## **RE: RESPONSE TO REQUEST FOR ADDITIONAL INFORMATION – DA2024/1079**

### **PROPERTY AT 53, 53A AND 53B WARRIEWOOD ROAD, WARRIEWOOD**

Proposed Community Title Subdivision – DA2024/1079

**TABLE 1 – RESPONSE TO COMMENTS**

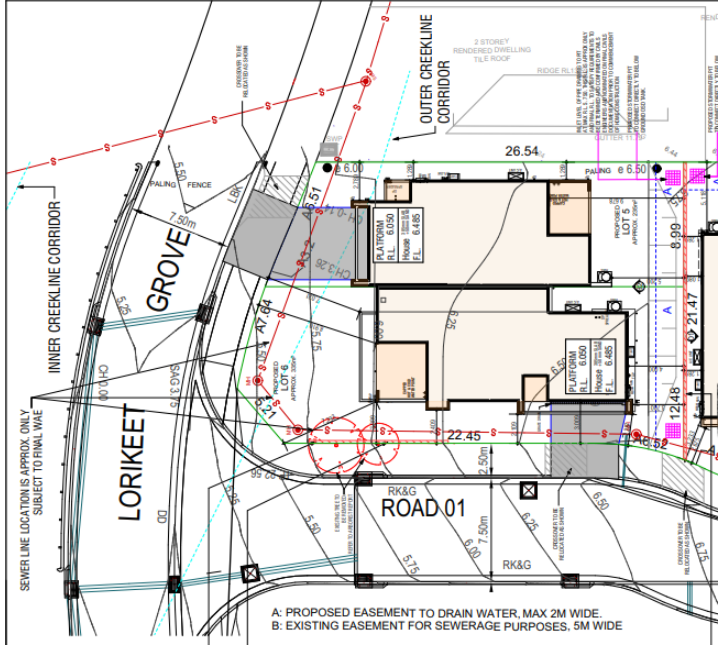
<ul style="list-style-type: none"> <li>The 2.5 metre wide sharepath located within the outer creekline corridor must be located above the 20% AEP flood level and must adjoin with the existing approved sharepath location(s) on adjoining allotments.</li> </ul>	As shown on the revised Civil Engineering Plans provided in <b>Appendix 3</b> , the 2.5m wide shared path has been relocated to extend parallel to Lorikeet Grove, connecting to the north and south. The path will be located above the 20% AEP. It is noted that shared paths do not currently exist within the neighbouring developments however we have aligned the pathways to accord with the relevant approvals. Works beyond the Subject Site boundary are expected to be undertaken by other parties.
<ul style="list-style-type: none"> <li>Residential accommodation is not permitted within the creekline corridor.</li> </ul>	<p>All dwellings and garages are located outside of the creek corridor. Boundary fencing and landscape areas for the proposed Lots 4 &amp; 5 result in a very minor encroachment of the outer creek line corridor. This is consistent with the approved developments in Warriewood Valley, including Lorikeet Grove.</p> <p>The proposed front boundary of the proposed Lots 4 &amp; 5 is dictated by the contour of Lorikeet Grove, the required verge and residential boundary of No. 21 Lorikeet Grove and No 2 Ibis Place, Warriewood. The proposal represents in fill development to link and continue the extension of Lorikeet Grove west and east of the Subject Site. The dwellings referenced above are also located in the outer creek line corridor and have been previously approved on this basis and set existing precedence. Enforcing strict compliance in this instance would result in an inconsistent subdivision pattern and reduced streetscape outcomes as the future dwellings would be required to be setback considerably from those approved to the north.</p>

TABLE 1 – RESPONSE TO COMMENTS	
Comment	Response
	<p>The built form Development Application under DA2024/1847 was lodged with Council on 15 January 2025 and shows no habitable built form proposed in outer creekline corridor as shown in extract below.</p>  <p>A: PROPOSED EASEMENT TO DRAIN WATER, MAX 2M WIDE. B: EXISTING EASEMENT FOR SEWERAGE PURPOSES, 5M WIDE</p> <p>A condition of consent may be imposed which requires that no habitable built form is undertaken within that area, with the exception of the front fencing and landscaping.</p>
<p><b>6. Landscape</b></p> <p><i>The landscape plans are to be updated to include the following information:</i></p>	<p>The Landscape Plans (<b>Appendix 11</b>) have been updated to reflect Council's requested information including:</p> <ul style="list-style-type: none"><li>2.5m wide shared path above 20% AEP flood level;</li></ul>

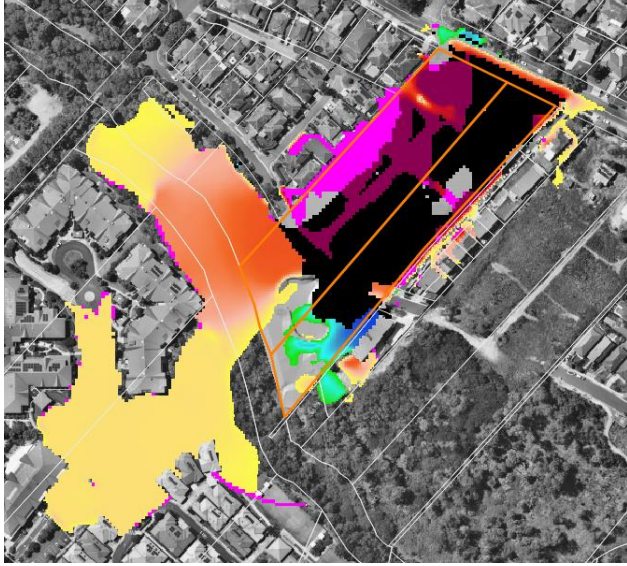
(B) <b>Wetland / Raingarden Solution</b> – <i>Based on discussions with Council</i>	This solution is consistent with what was presented in December's meeting with Council. Enspire agreed to work through a wetland / raingarden solution within the downstream Creekline corridor, provided flooding outcomes could be achieved.  The proposed strategy that was agreed in principle involved: <ul style="list-style-type: none"> <li>Introducing an additional crest within Lorikeet Grove which then resulted in 2 'sags' in the road. Existing road levels maintained to the north and south (within existing developments);</li> <li>Proposed wetland infrastructure similar to that presented in SK0023. Refer SK0023 for an indication which was issued to Council;</li> <li>Provision of a GPT upstream of the wetland, although inundated in various flood events; and</li> <li>Construction of a maintenance access ramp to the wetland.</li> </ul>	CSS confirmed that by incorporating the wetland or raingarden ( <b>Appendix 12</b> ), adverse flooding impacts were being reported within the mainstream area due to the elevated terrain within the wetland. It was found that the wetland was a major contributor to increases in flood levels and adverse flood behaviour. The wetland or raingarden essentially acts as an impediment to flow. An image extracted from the preliminary wetland / flood scenario is shown below.

Option / Solution	Civil Engineering Assessment	Flooding Outcomes
	<p>Enspire worked through the above strategy, including a revised 3D terrain model which was then assessed by CSS (Flooding) to determine flooding impacts. Refer column adjacent for outcomes.</p> <p>As a result of flooding outcomes (right), and due to site constraints, i.e., required location and levels of Lorikeet Grove, location of existing sewer carrier mains within the inner/outer creek line corridors, location of existing trunk drainage main, limited area available for ‘flood storage’, and the requirement to have lots located above the relevant flood levels, it is therefore not feasible for a wetland and raingarden to be incorporated into the Subject Site. The wetland or raingarden would also be inundated in majority of storm events.</p>	
<p>(C) <b>OSD, Water Quality Tanks and Vegetated Swale</b> – Current Design</p>	<p>Current solution presented on the revised Civil Engineering Plans (<b>Appendix 3</b>). The Water Management strategy reverts back to the original scheme presented in (A), although with the introduction of a vegetated swale within the outer Creekline corridor. The vegetated swale is proposed at the outlet of the drainage outlet. The water quality treatment train now consists of</p> <ul style="list-style-type: none"> <li>(i) Rainwater tanks (future house builds);</li> <li>(ii) Pit filter inserts within the road drainage pits (to remove gross pollutants);</li> <li>(iii) Proprietary water quality filter cartridges within the tanks, and</li> <li>(iv) Vegetated swale at the outlet.</li> </ul>	<p>The outcomes of the flood assessment adopting this water management strategy indicate that no adverse impact to flood level or velocity are predicted outside of the development site within the mainstream area of Narrabeen Creek in all flood events. It is noted that changes to flood behaviour are predicted on Warriewood Road as a direct result of frontage works and roadworks in this location, but these are not predicted to impact adjacent lots in all events up to and including the 100-year ARI (with climate change).</p>
